1. Review “BT Ambler LLC – Mixed Use Development” proposing a mixed-use development at 100 – 112 W. Butler Avenue and 19, 23, and 27 S. Chestnut Street under the TOD option in the Redevelopment Overlay District pursuant to ordinance amendment request to Ordinance No. 1140 Recommendation requested from the applicant.

Reference: Sketch Plan Application  
BT Ambler, LLC  
100-112 West Butler Avenue and 19, 23 & 27 Chestnut Street

**SUBJECT:** Tentative Sketch Plan Review - BT Ambler, LLC – Mixed-Use Development (MCPC #25-0175-001)

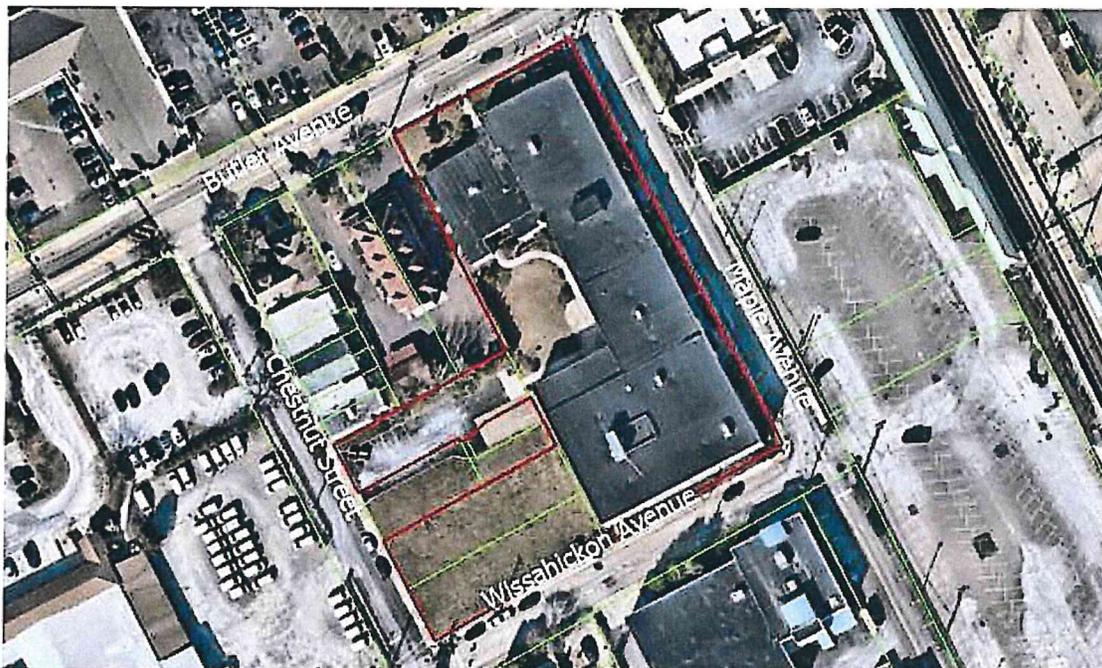
2. A primary example of a requirement under Section 2703.E that could alter the ultimate site layout is the required public gathering space associated with a TOD. These gathering spaces must be “integral to the development and designed as a focal point for the transit-oriented development” pursuant to Section 2703.E.(4)(f)1. The borough should consider if the proposed location and design meets this requirement, considering that the proposed location is on a secondary street frontage. Furthermore, the conceptual site plan lacks adequate detail to confirm if the minimum requirements for a gathering space pursuant to the ordinance are met. As proposed, it appears to be a winding sidewalk within a 20-foot front setback area. Without details on proposed furnishings, as required by Section 2703.E.(4)(f)5, and proposed landscaping, as required by Section 2703.E.(4)(f)6 and 2703.E.(4)(f)9, the borough is unable to ensure that the design is compliant with the requirements for such. Should the applicant proceed with a preliminary plan, the borough should consider requesting additional detail for this area – such as the landscaping plan, streetscaping design, and proposed street furnishings – to ensure that the design can meet the minimum requirements of the ordinance before further site planning is undertaken.
